# WATER QUALITY M E M O R A N D U M

Utah Coal Regulatory Program

RE: 2010 First Quarter Water Monitoring, PacifiCorp, Trail Mountain Mine,  
C/015/0009, Task ID #3488

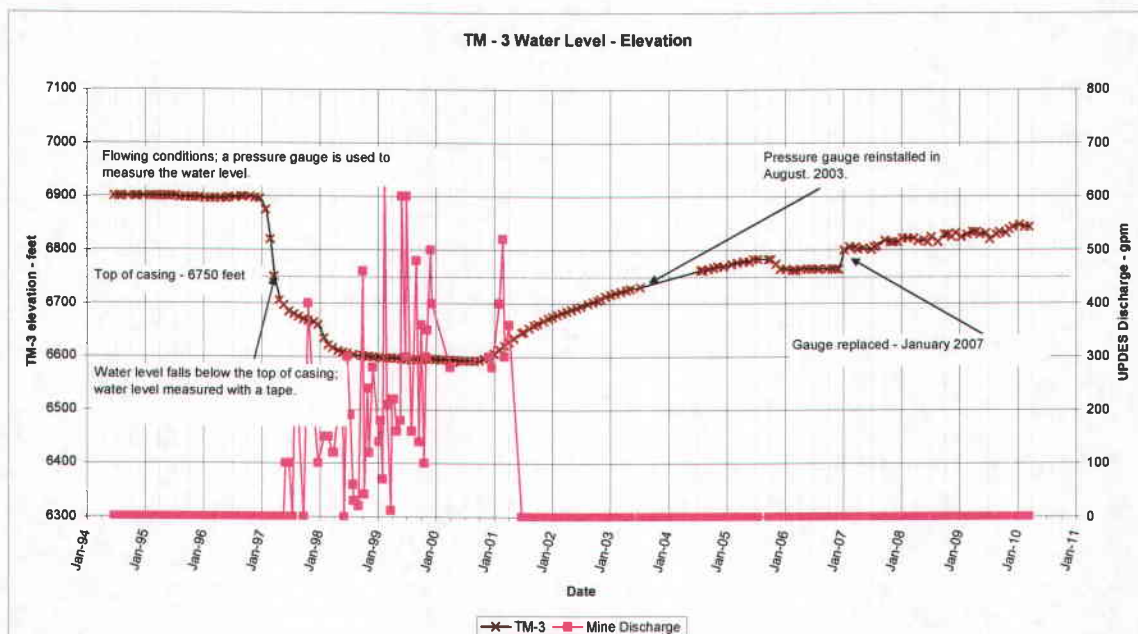
TM-1B March: depth. The head in TM-1B has been slowly rising since early 2003. The cause is not evident. Although highly variable from quarter to quarter, it may be establishing a new equilibrium. See the chart below.

TM-3: water elevation peaked in June 2005, remained steady through October, dropped 18.5 ft in November and December 2005 and remained virtually unchanged during 2006. The pressure gauge was replaced in January 2007 and values jumped to approximately match the pre-2006 curve. During the first half of 2007, the curve was relatively flat, but it resumed climbing during the third quarter and has continued on an upward trend. See the chart below.
